Noise Occurrence on GDB1363 and GDB1431

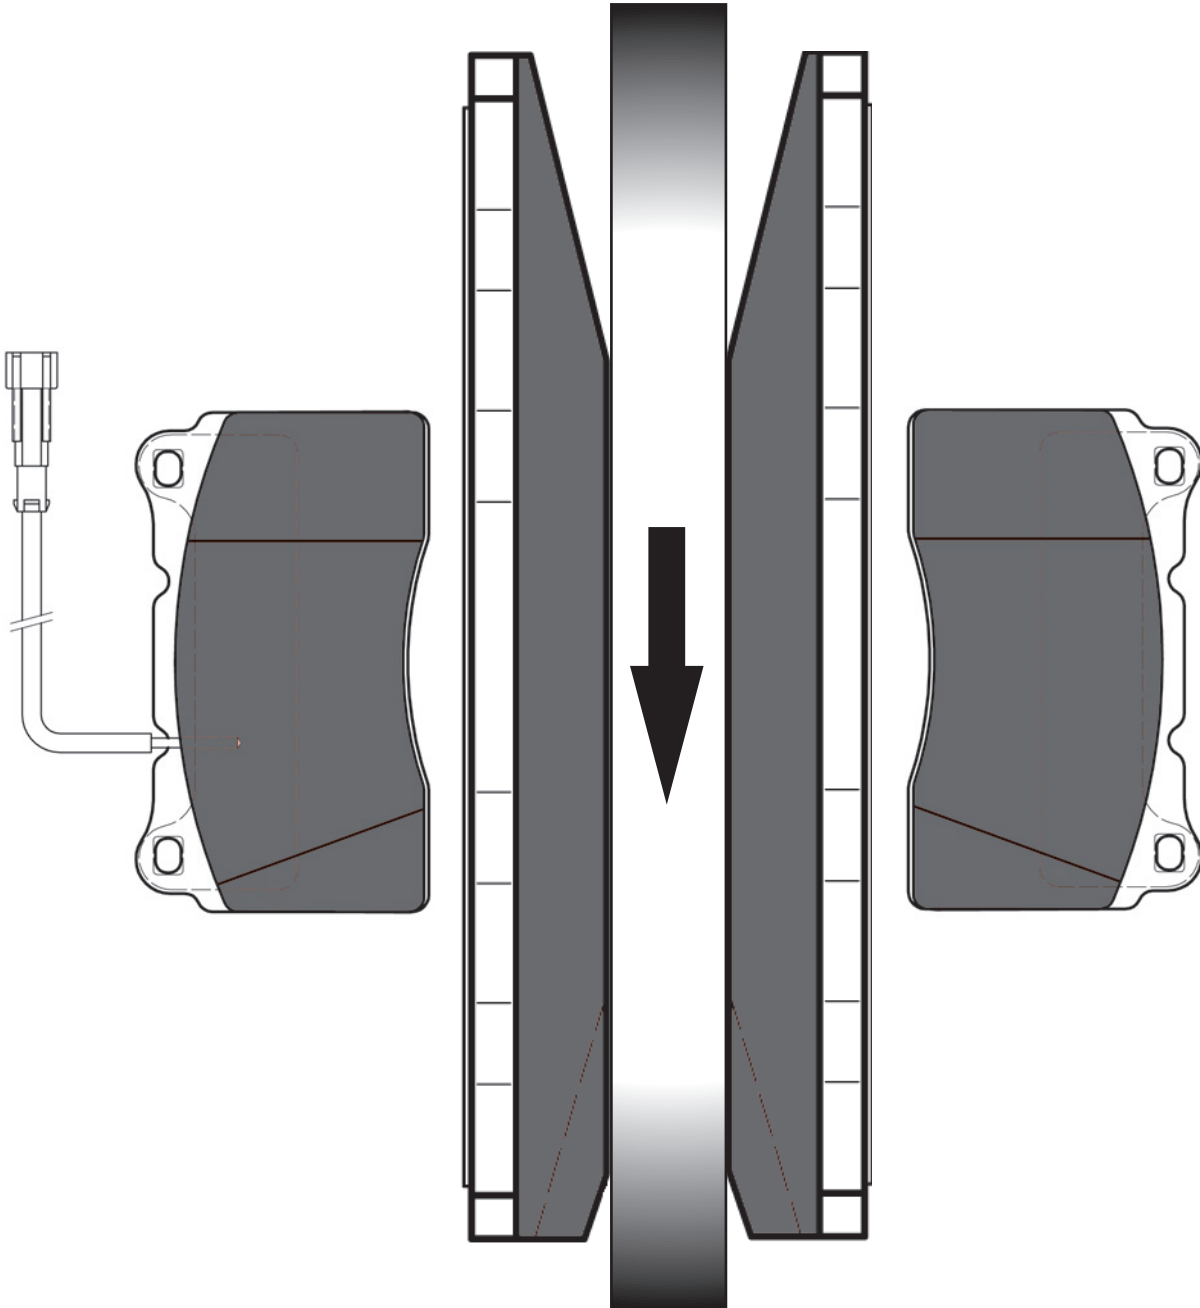
GDB1363 and GDB 1431 are chamfered on one side. The reason for this is to minimise noise. The arrow indicates the disc forward rotation. If the Brake Pads are not fitted as shown above, noise will occur. To ensure the correct fitment in future TRW will print indicator arrows on the back plate.
